## LOT 41 CARDUP SIDING ROAD, CARDUP STORMWATER MANAGEMENT PLAN - ADDENDUM

This addendum is to support the current Application for Development Approval which includes seeking approval to modify to the overall drainage system on Lot 41 Cardup Siding Road.

The current design is shown on attached **Drawing C350 Rev 3**.

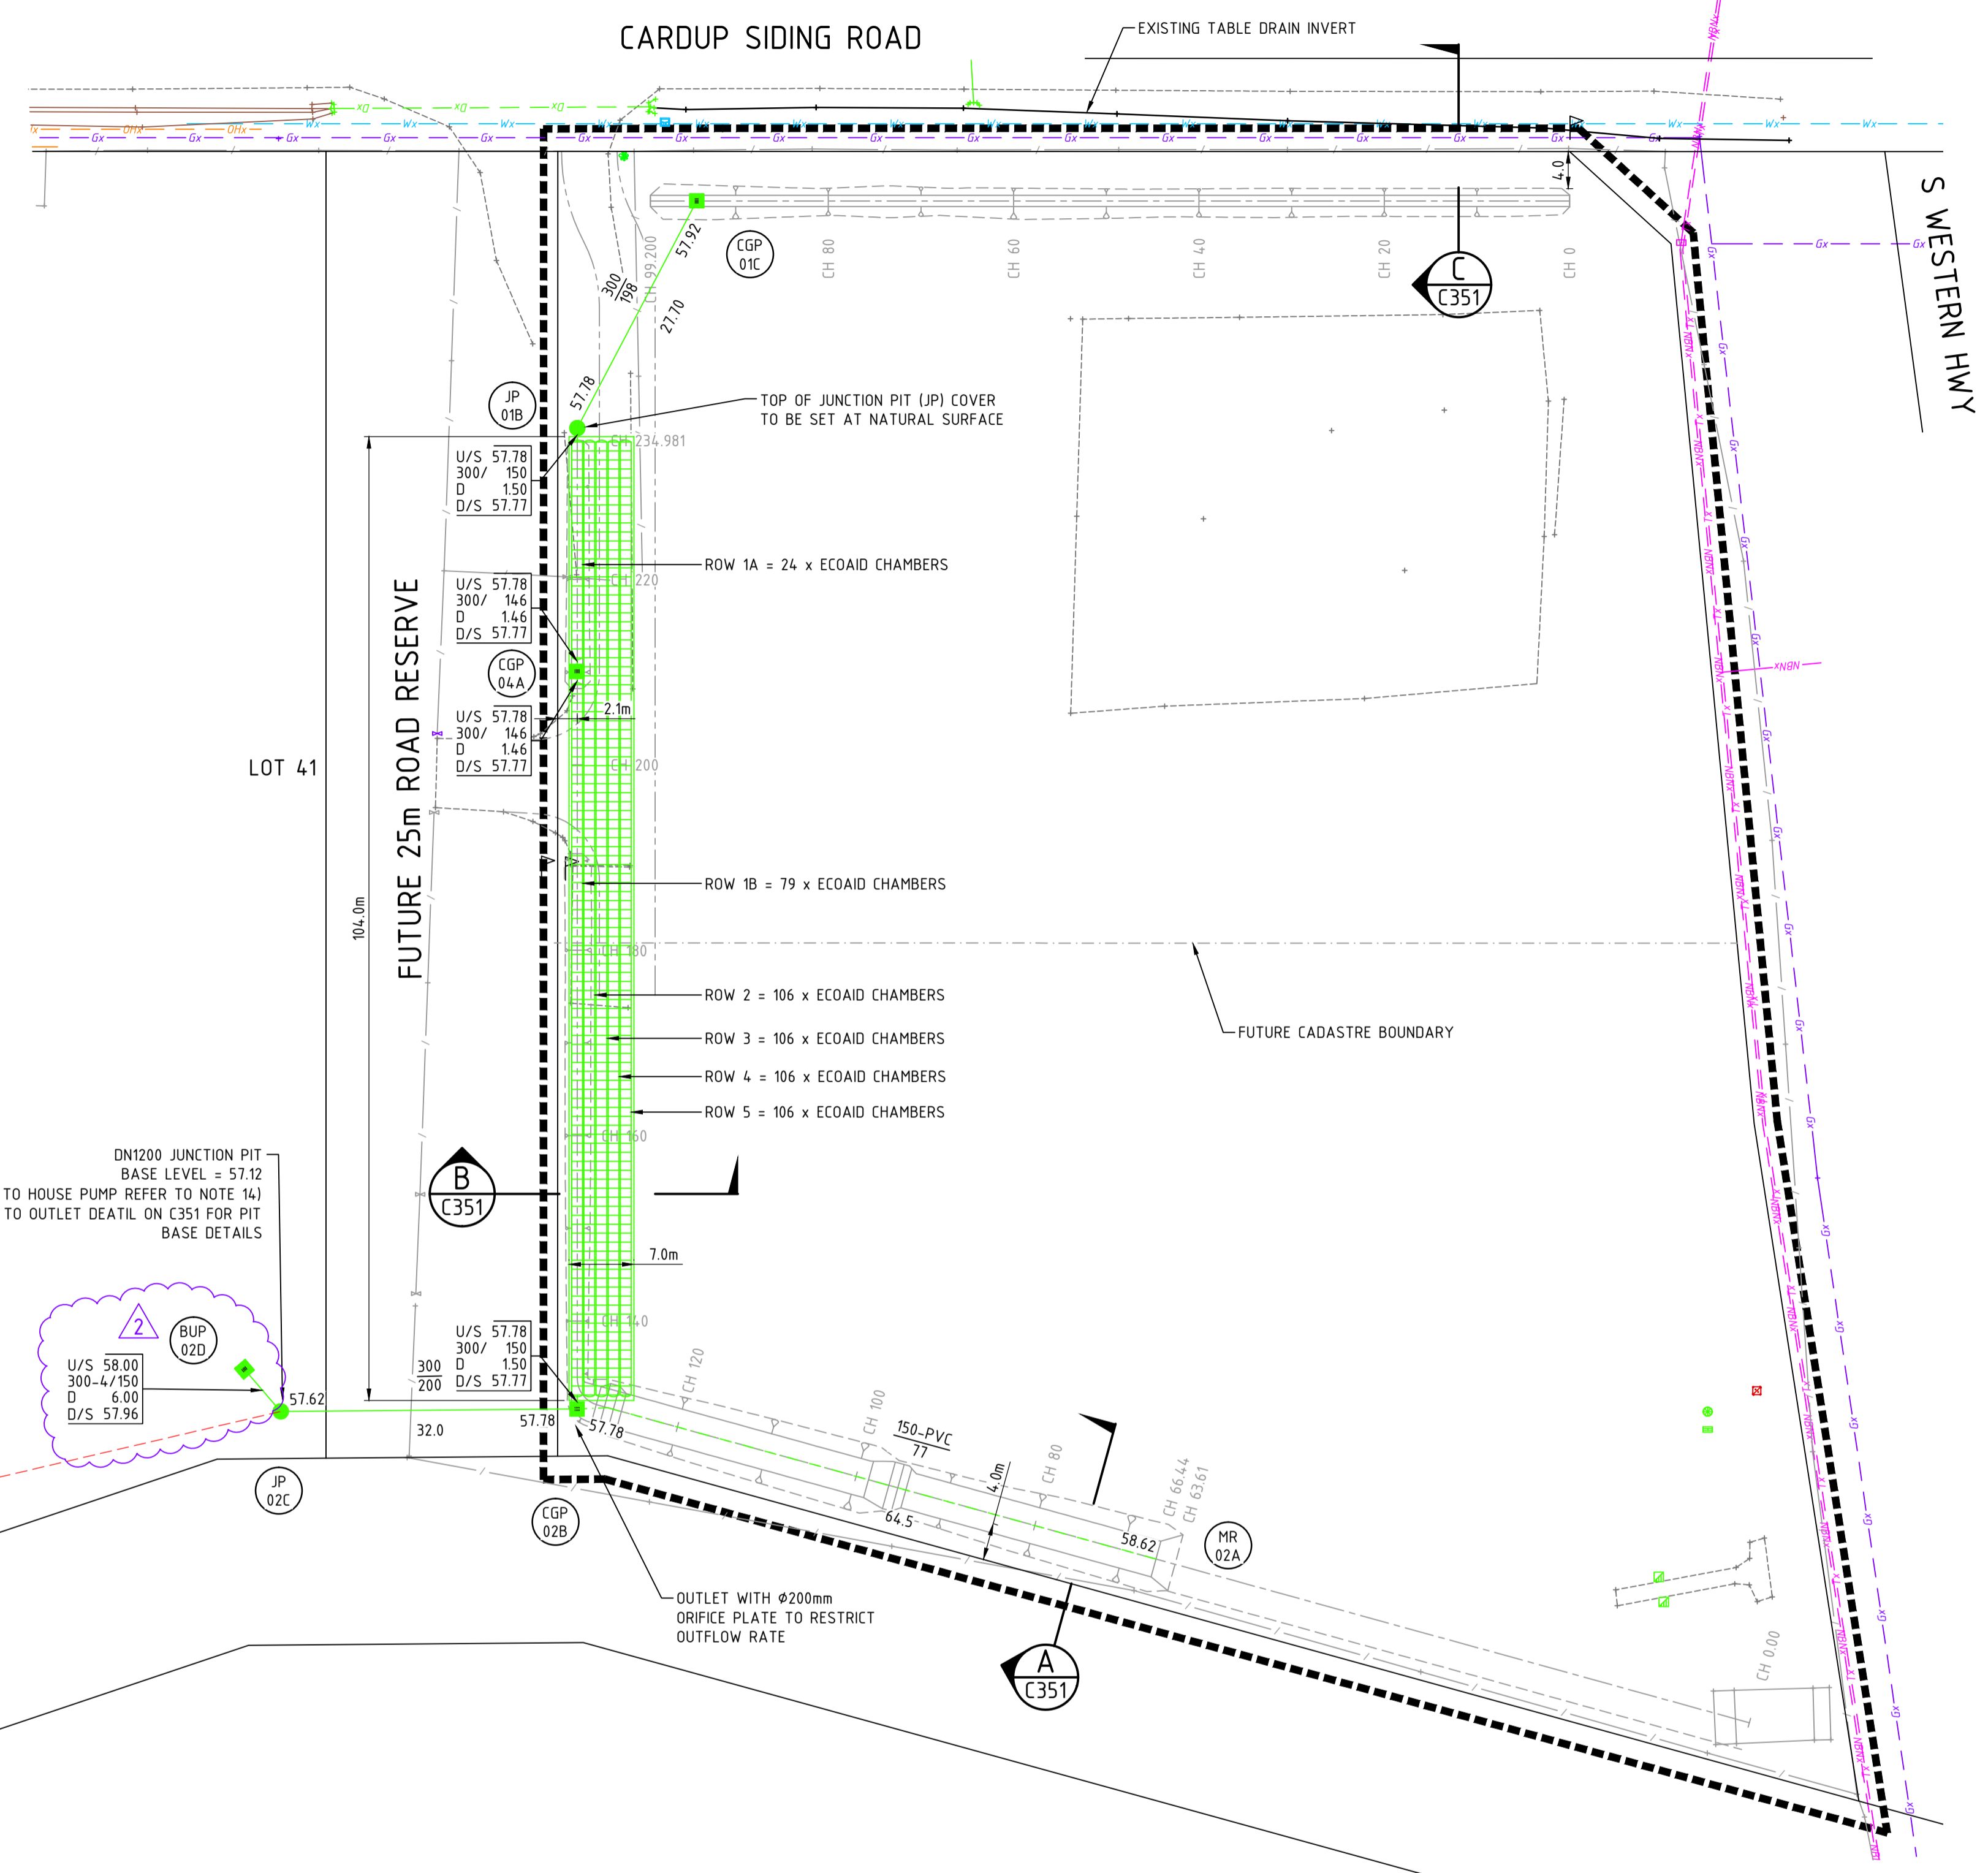
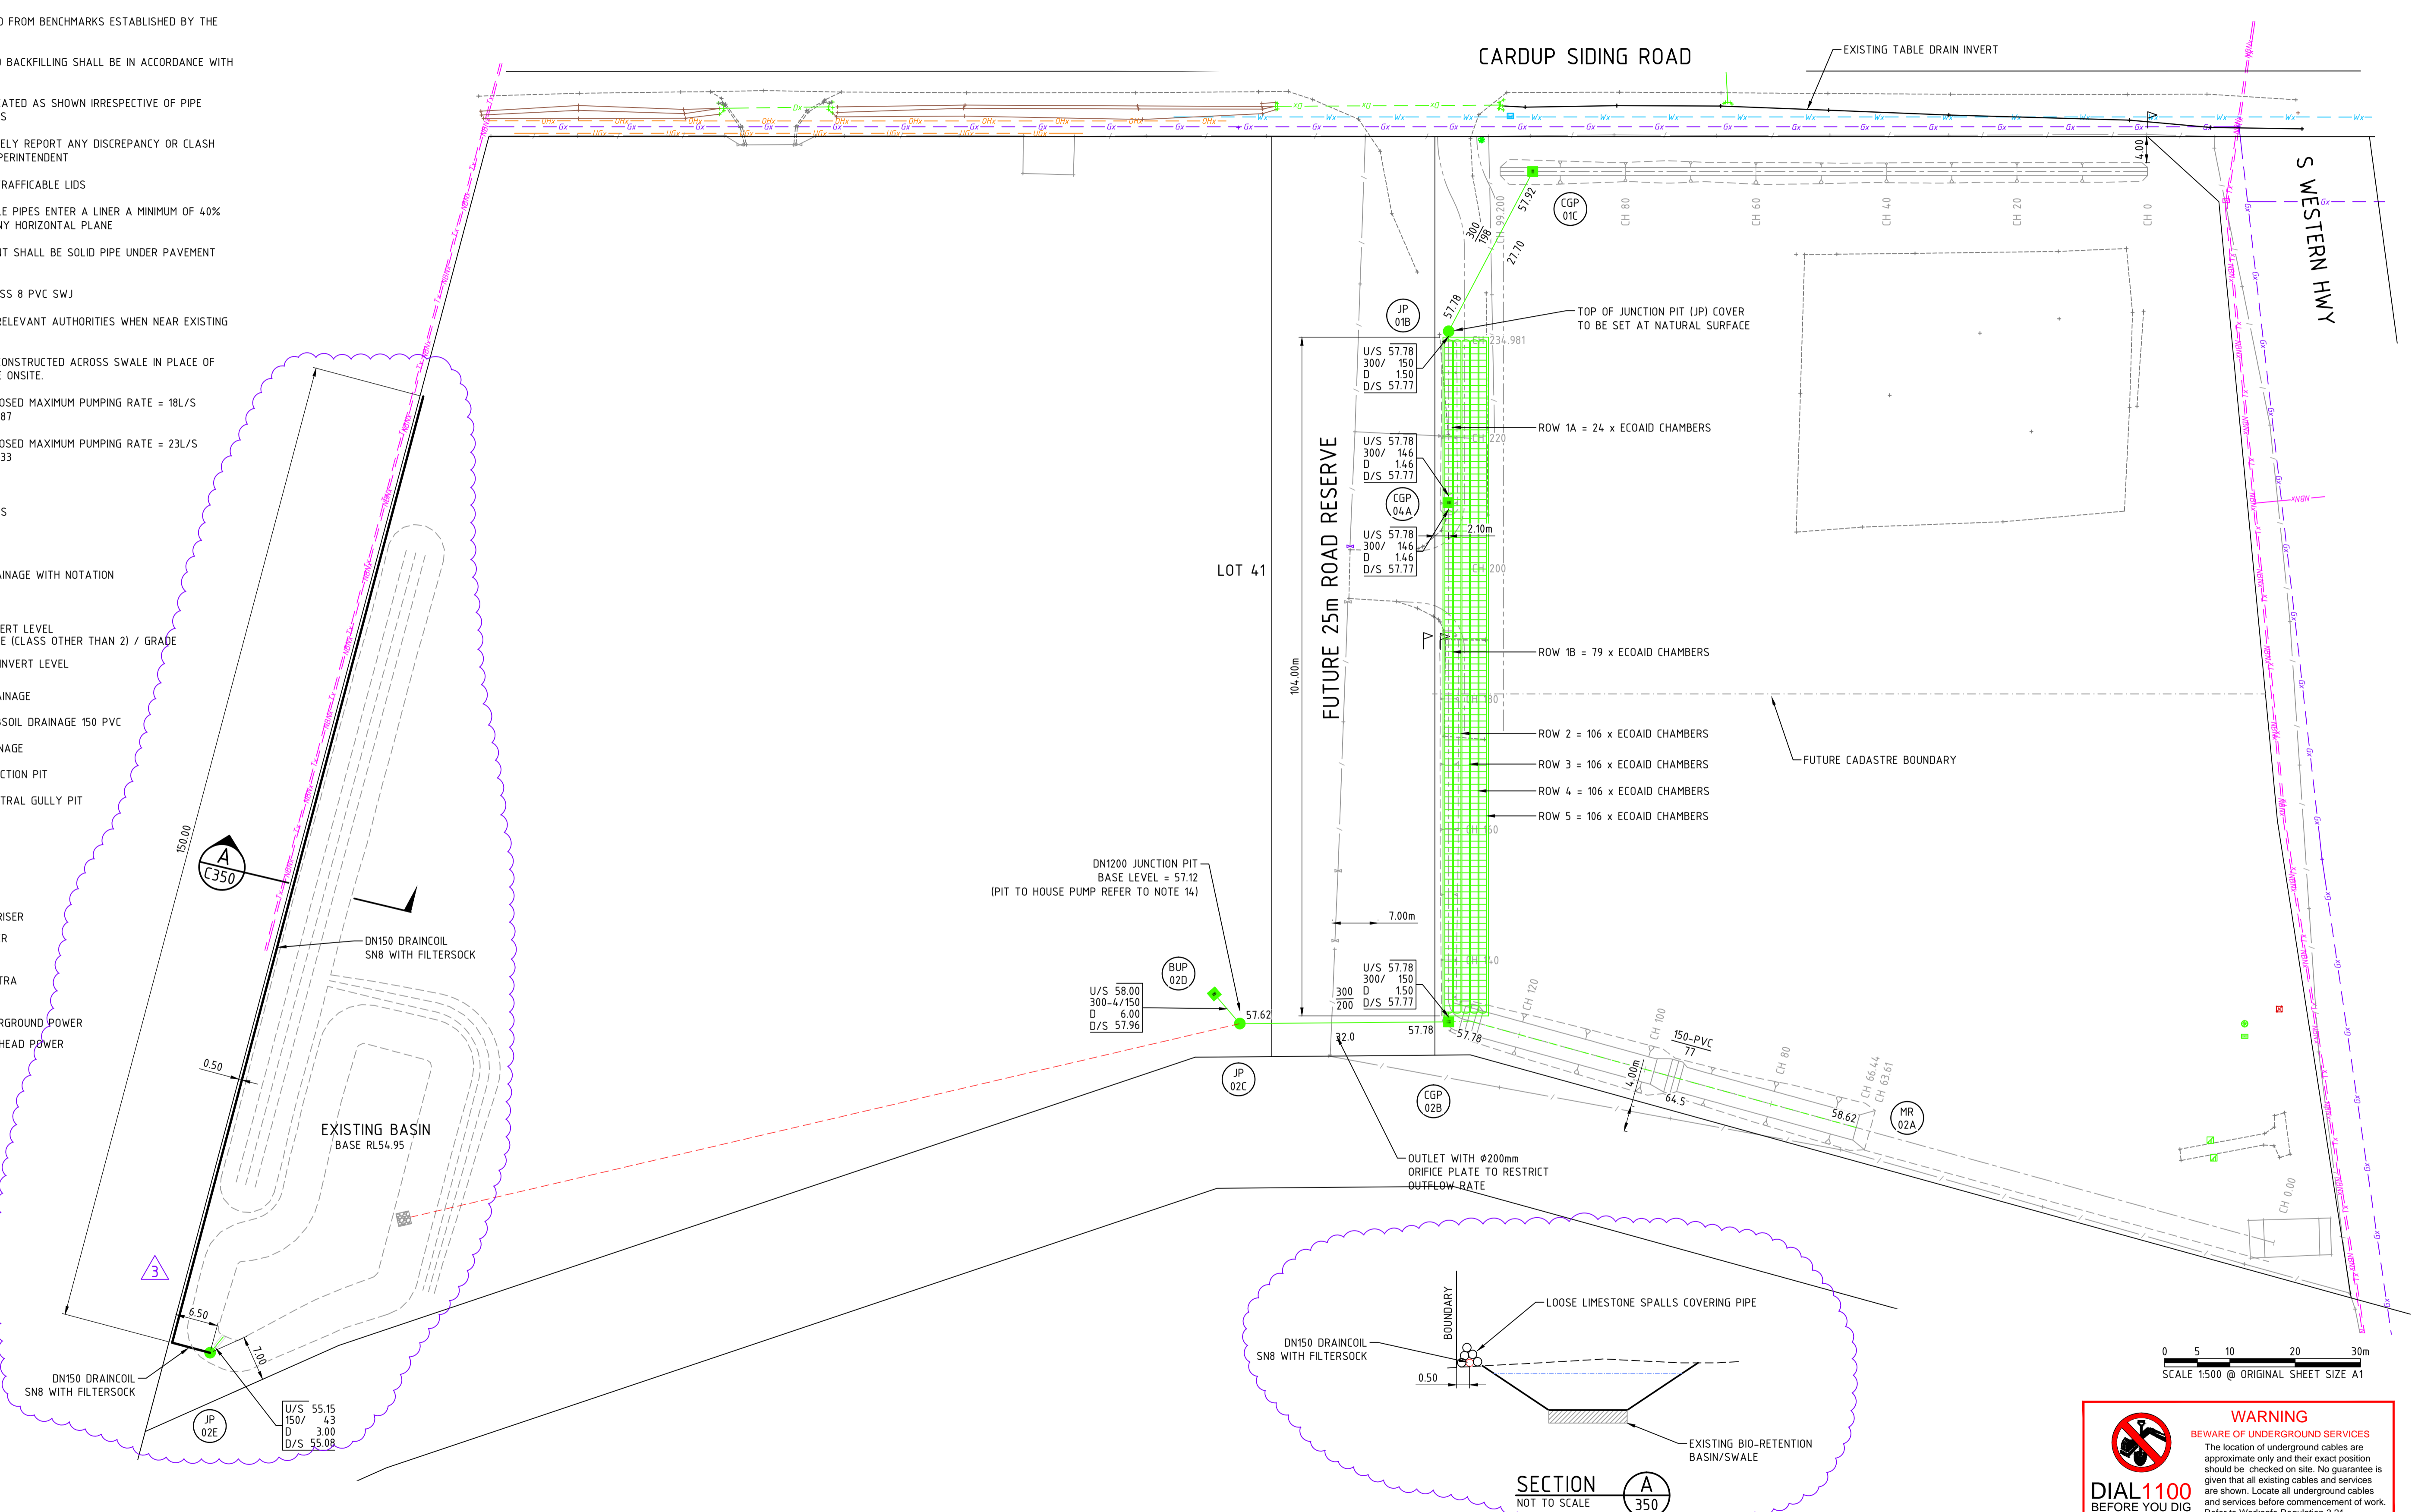
The design retains the original concept of all drainage in the eastern portion of the site, including the proposed new warehouse development, being directed to the bio retention swales and underground storage units then pumped to the drainage basin to enable gradual emptying.

Drainage of the western portion of the site remains unchanged apart from modification to the discharge from the basin. It is now proposed to gradually discharge stormwater by pumping into a 150mm diameter perforated pipe which extends 150m along the western boundary of Lot 41. The pipe will be wrapped in a filter media (Flitersock) and be contained within loose limestone spalls covering the pipe. This will ensure stormwater slowly discharges along the length of the pipe in a controlled manner with no potential to cause scour.

The basin discharge pump will have a maximum pumping rate of 23 litres per second which is roughly 8% of the calculated pre-development flow. Discharging over the 150m length also mimics the pre-development sheet flow conditions rather than concentrating flow at a single discharge point.
